ADDENDUM No. 1
for
INDIANA STATE FAIR COMMISSION
DISCOVERY HALL TENANT
IMPROVEMENTS
1202 East 38th Street
Indianapolis, Indiana 46205

July 8, 2011

Cripe Architects + Engineers
3939 Priority Way South Drive
Suite 400
Indianapolis, IN 46240
Phone: (317) 844-6777
FAX: (317) 706-6464
www.cripe.biz

ADDENDUM NO. 1

ADD.1-1

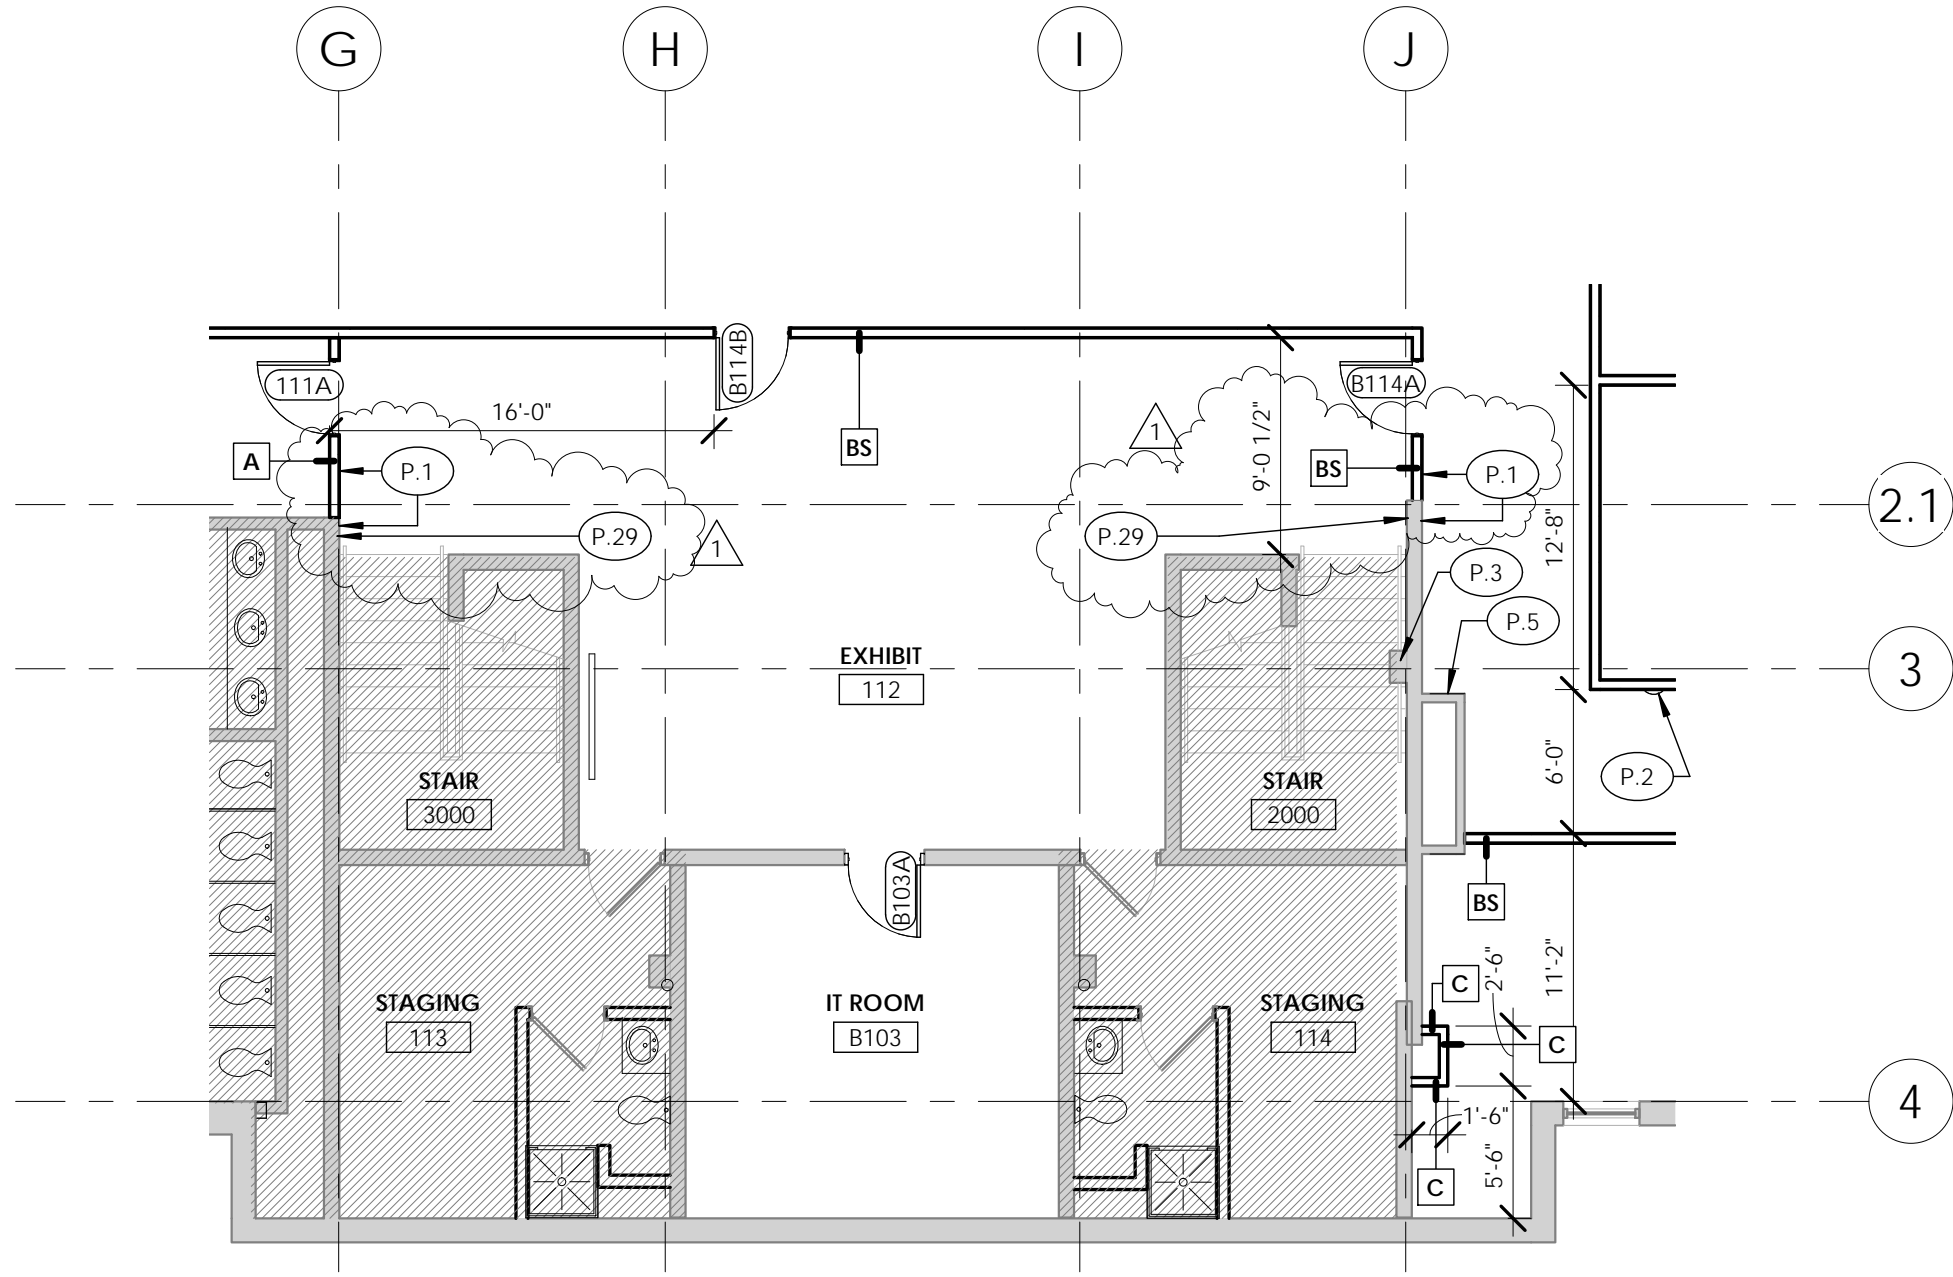
1. Add Plan Note to the Architectural Key Notes: P.29 PATCH BRICK AS REQUIRED TO MATCH ADJACENT EXISTING MASONRY FINISH. PROVIDE ALUMINUM WALL CAP TO COVER (+/- 6" in width, V.I.F) AND SEAL EXPOSED EDGES (SIMILAR TO PREVIOUS CONSTRUCTION PHASE).
2. Revise Drawing A101: Add Plan Note P.29 to wing wall locations at Exhibit 112. See Sketch ADD.1-1.

SHEET
ADD.1-3

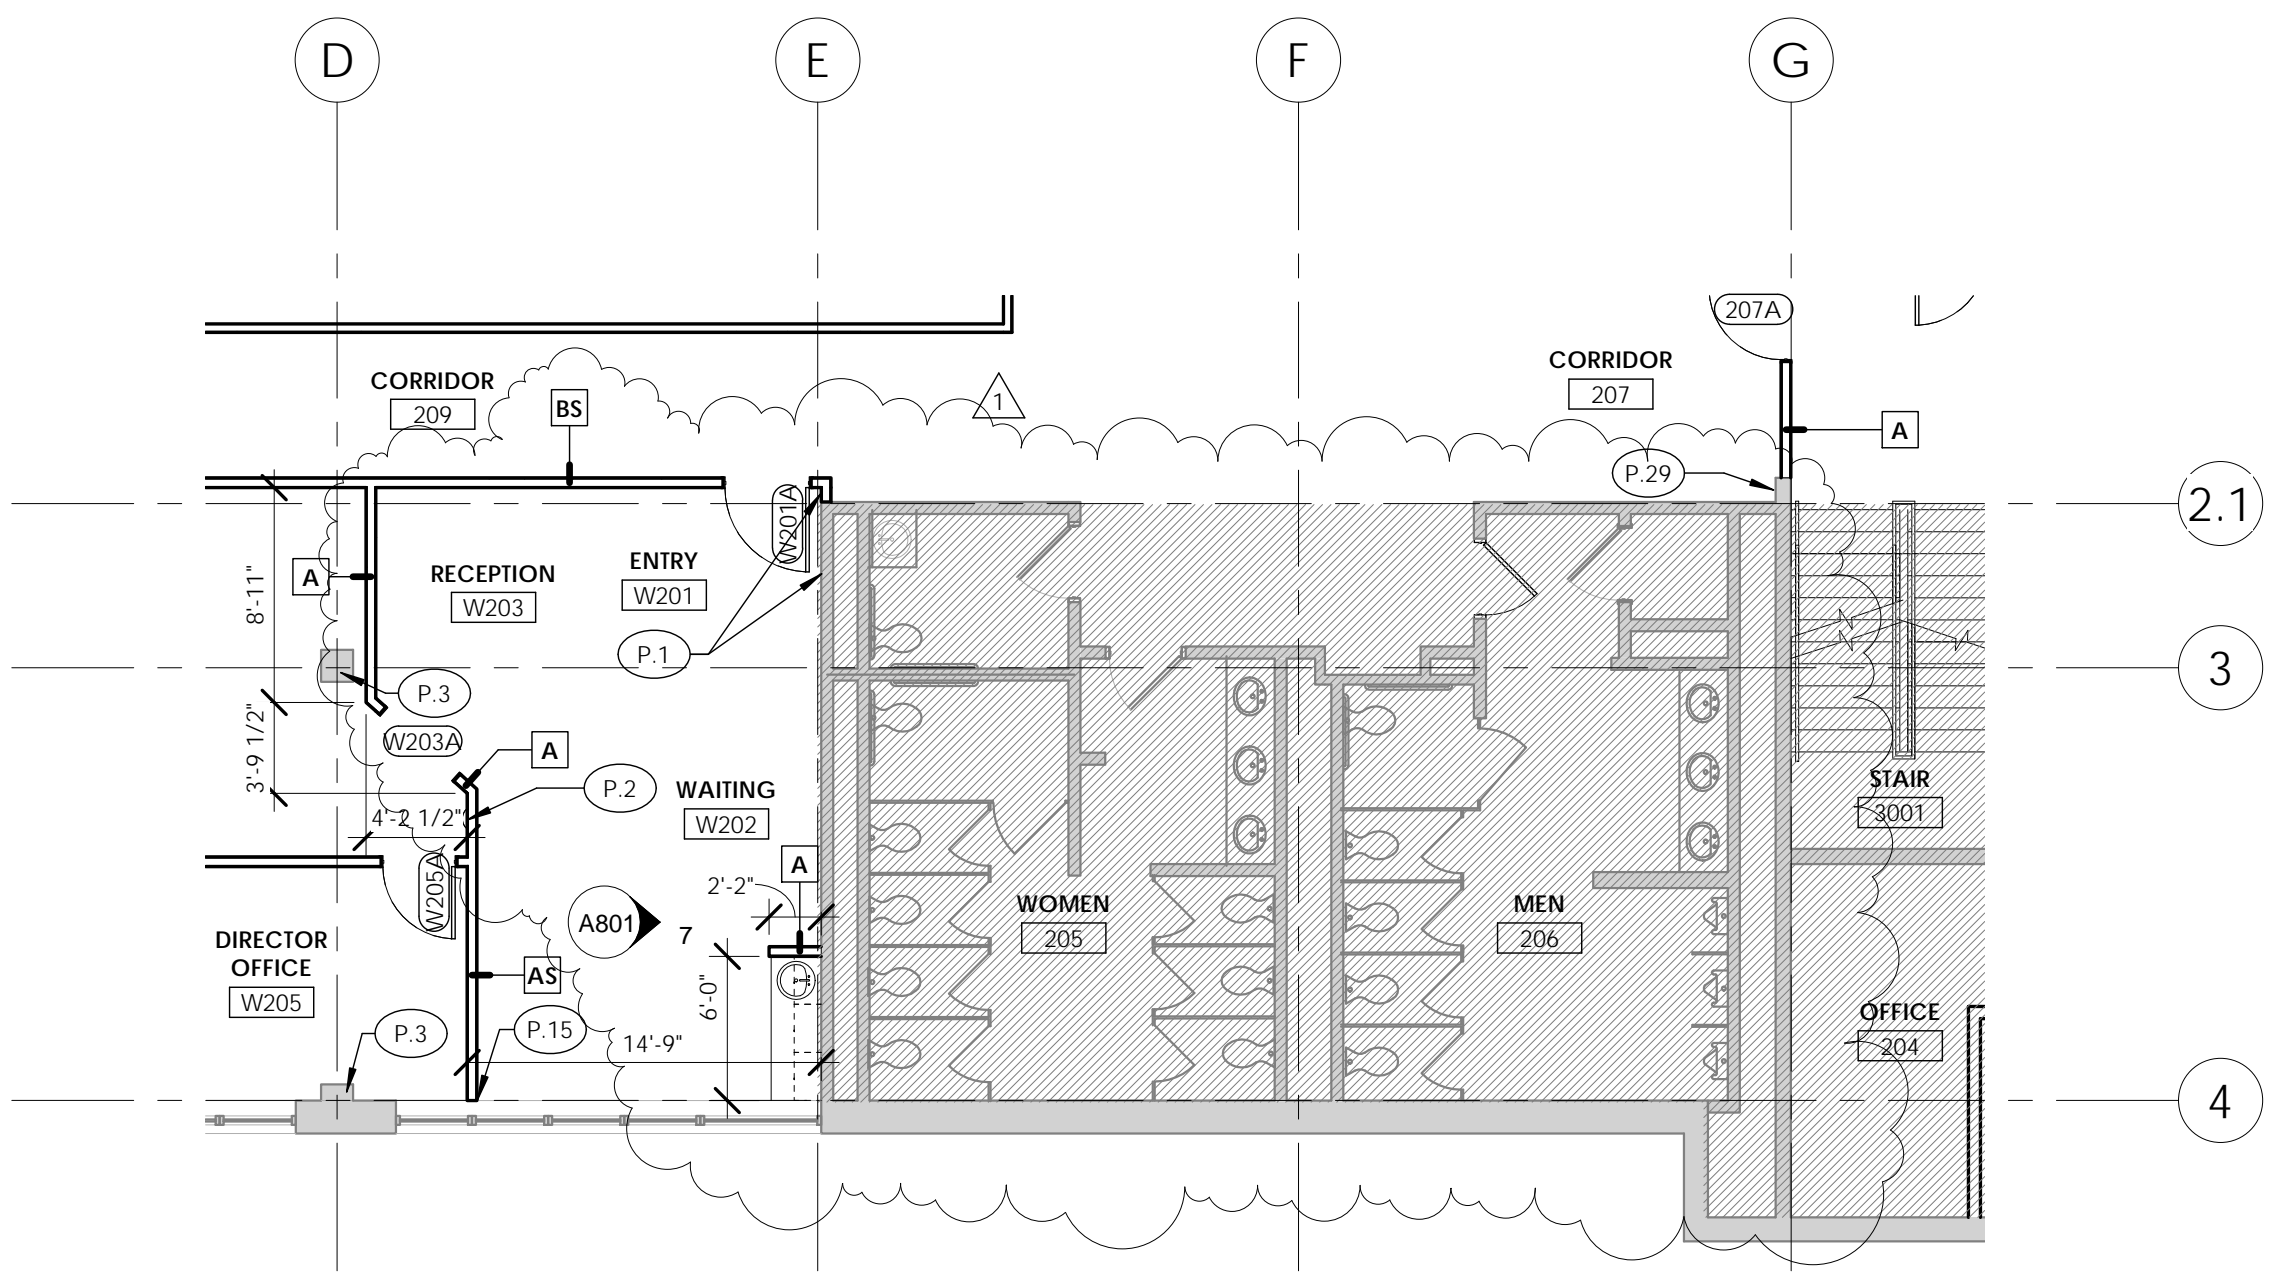
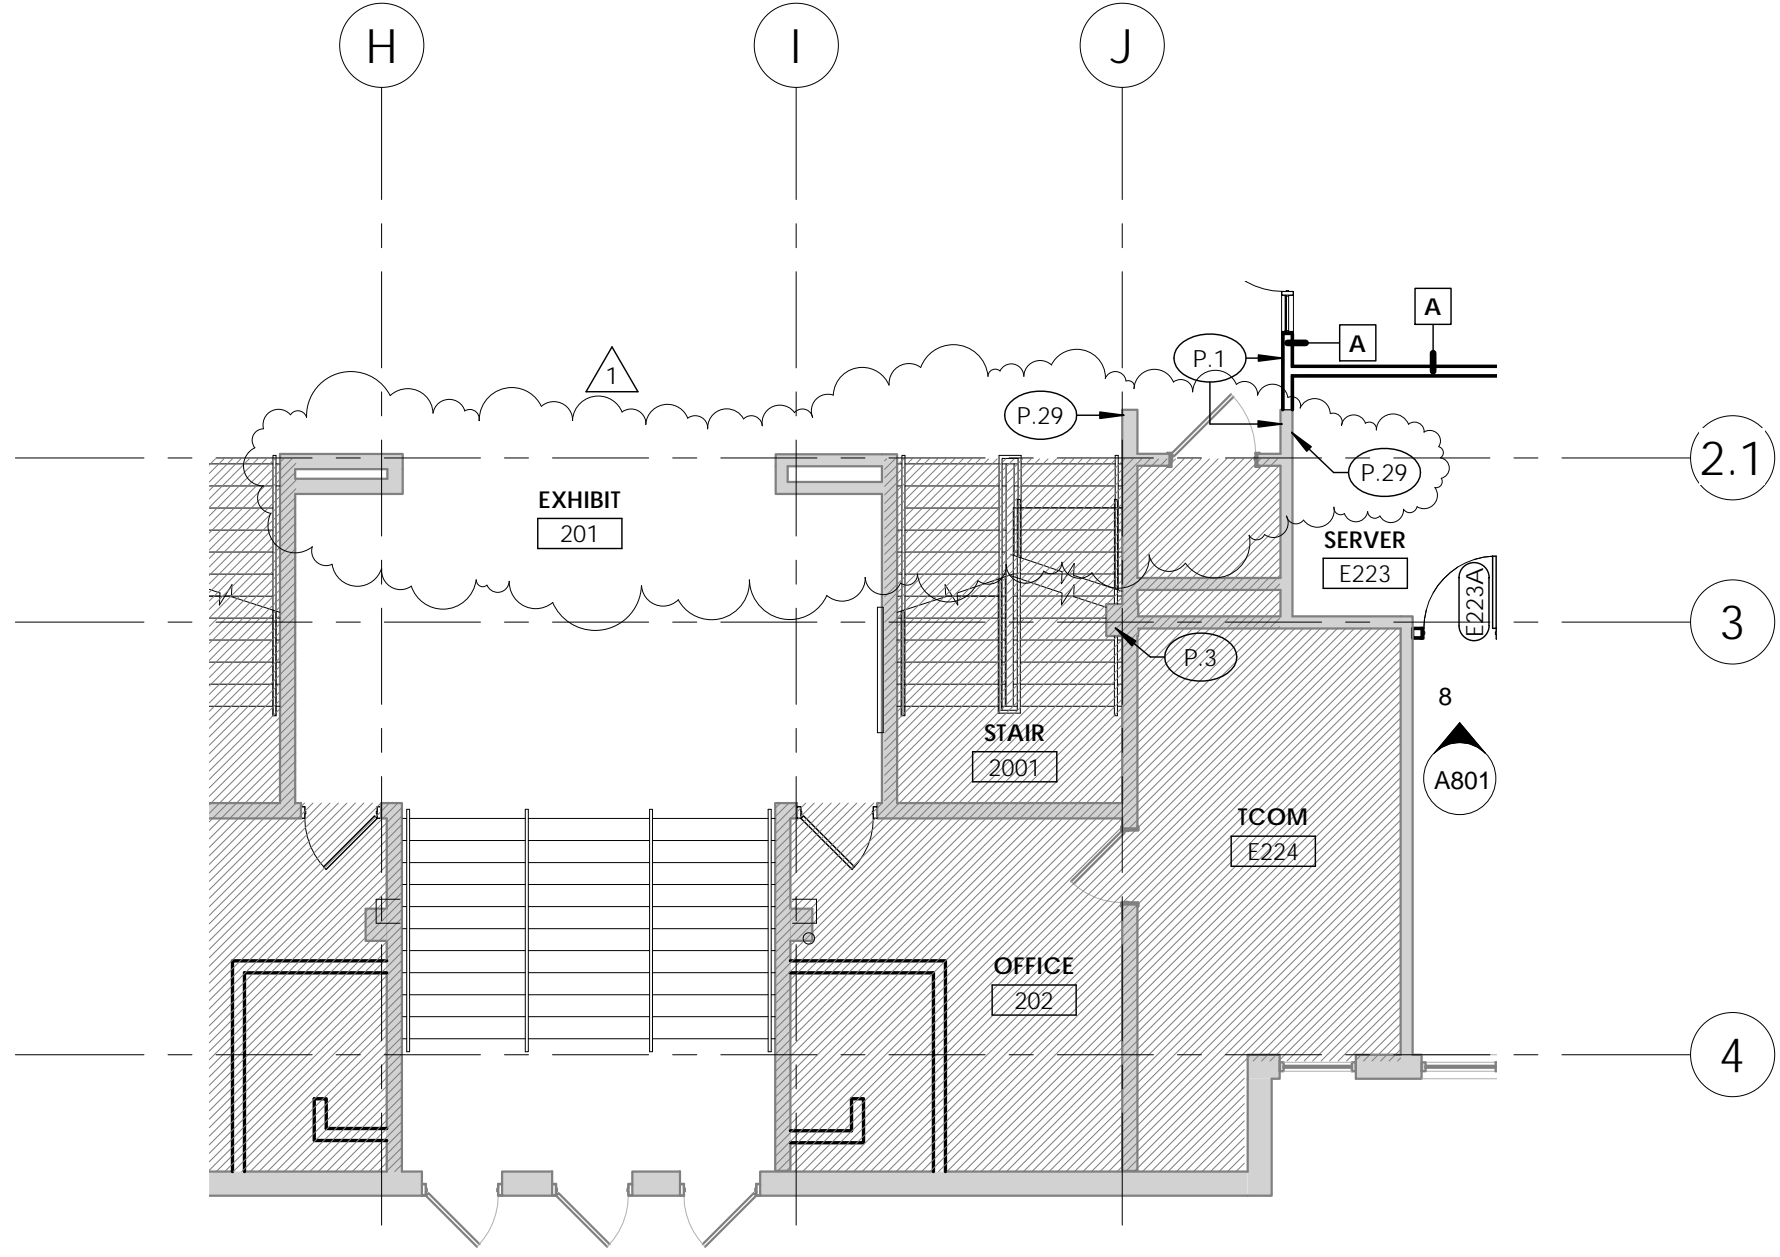
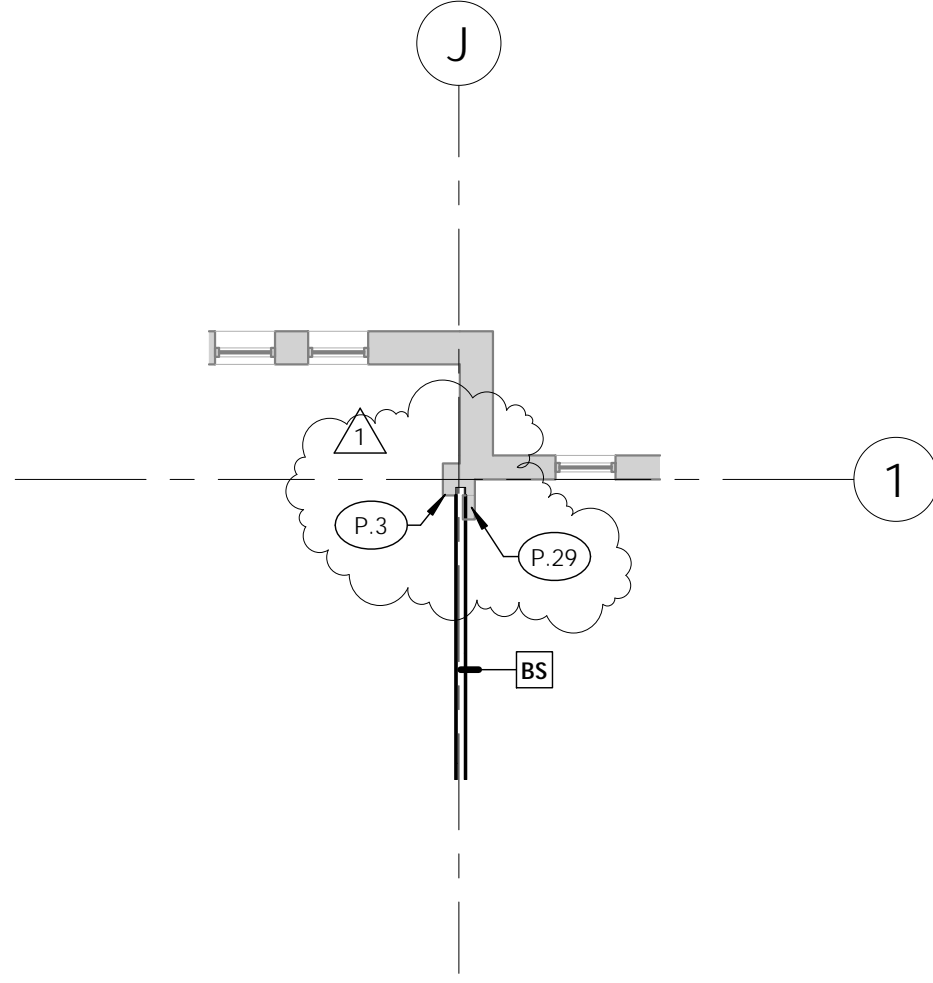
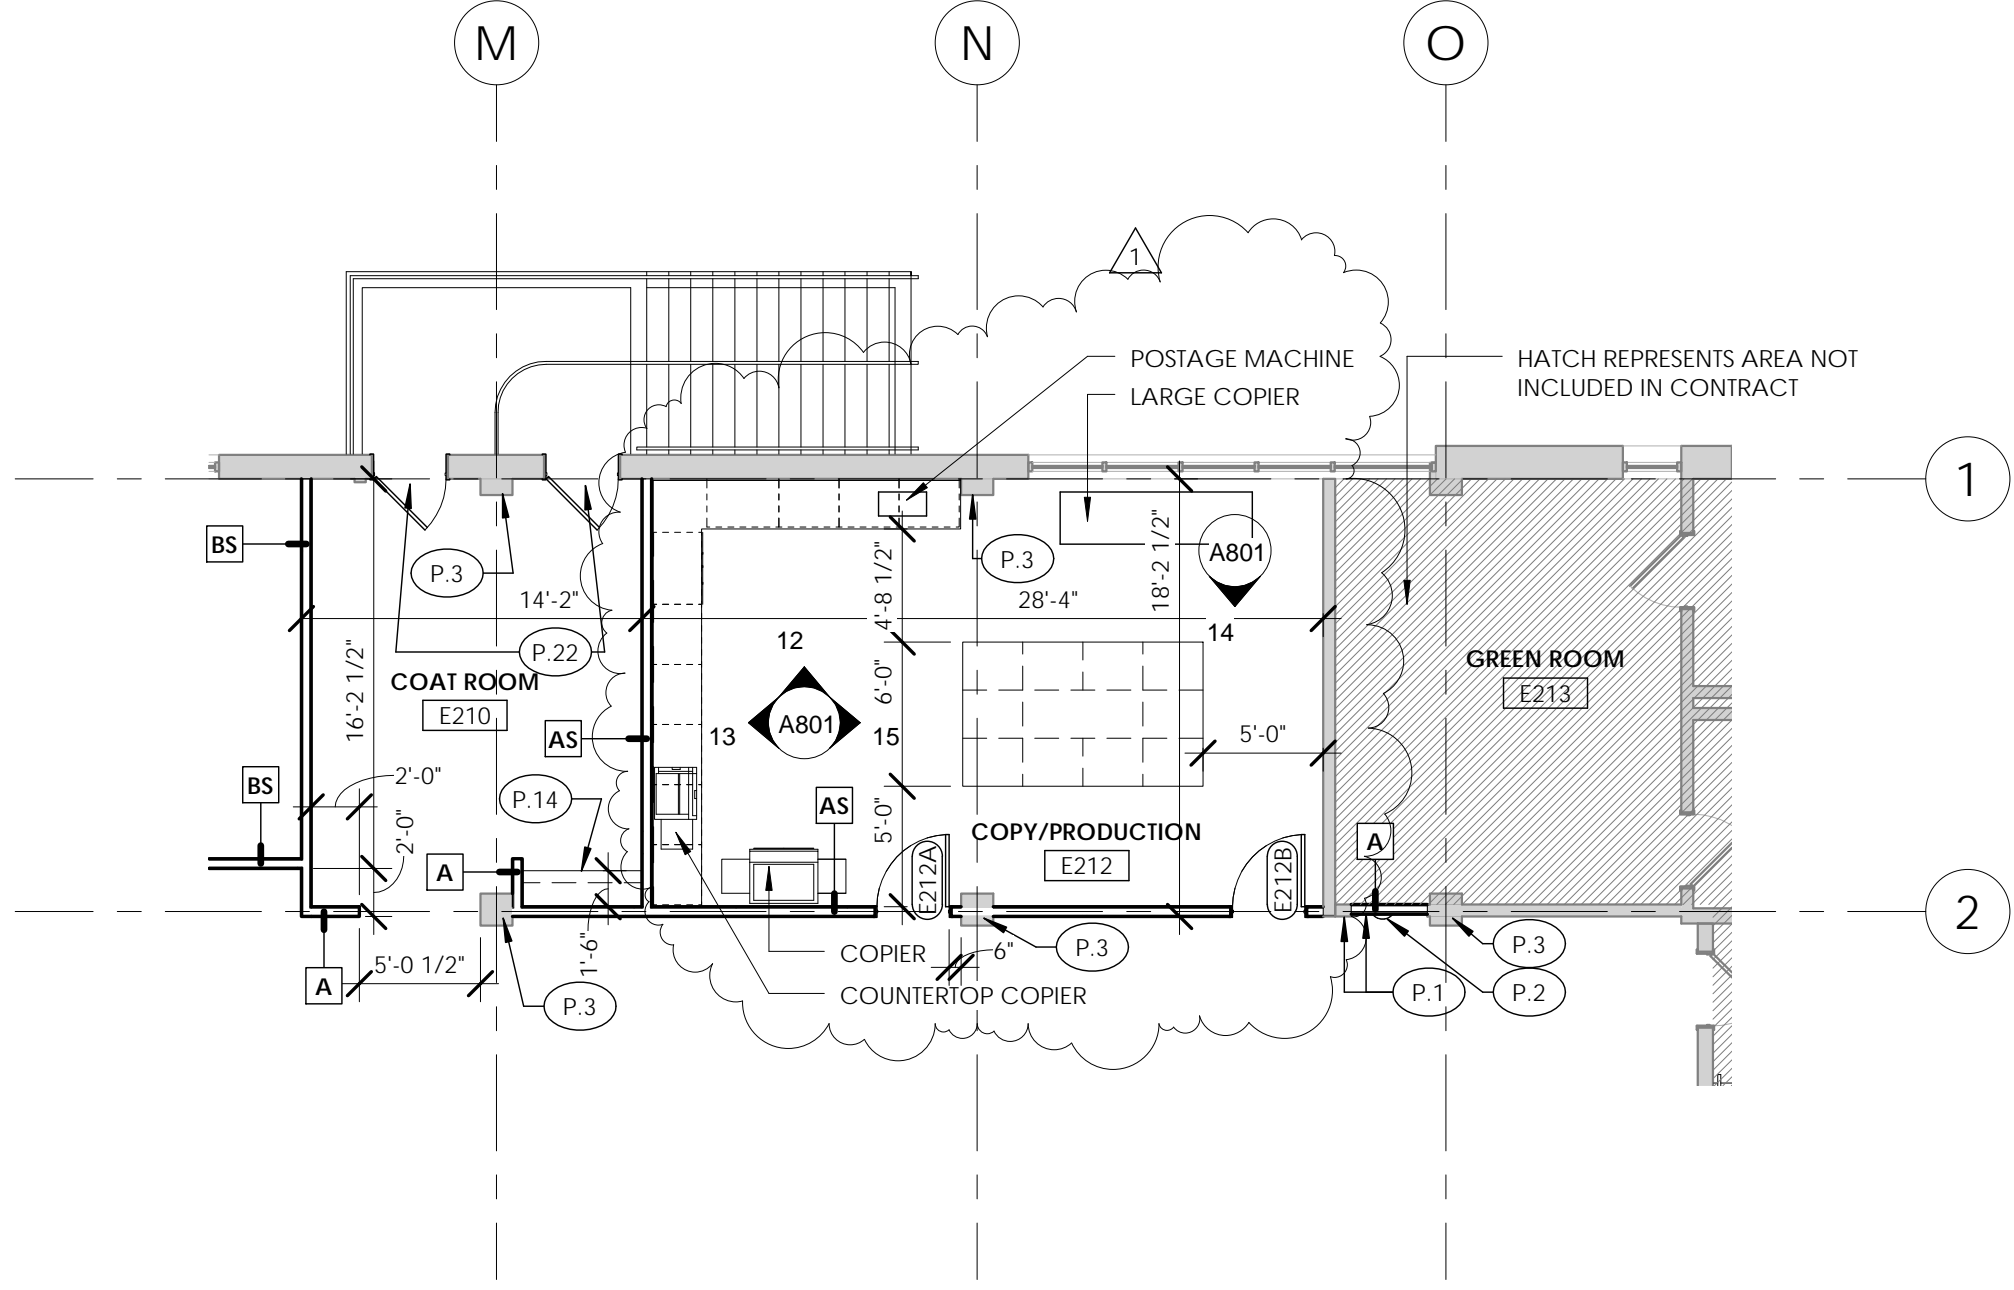
1. Revise Drawing A102 as indicated on Sketches ADD.1-2, ADD.1-3, ADD.1-4, ADD.1-5.
2. Room W203 indicates movable furniture provided by Owner. This is NOT casework at this location.
3. Detail 2/A102 shows a Steel Channel Column Repair. This is an EXISTING condition.
4. Patch, repair, and paint, as necessary, brick near Stair 4001 (located in Corridor 211).
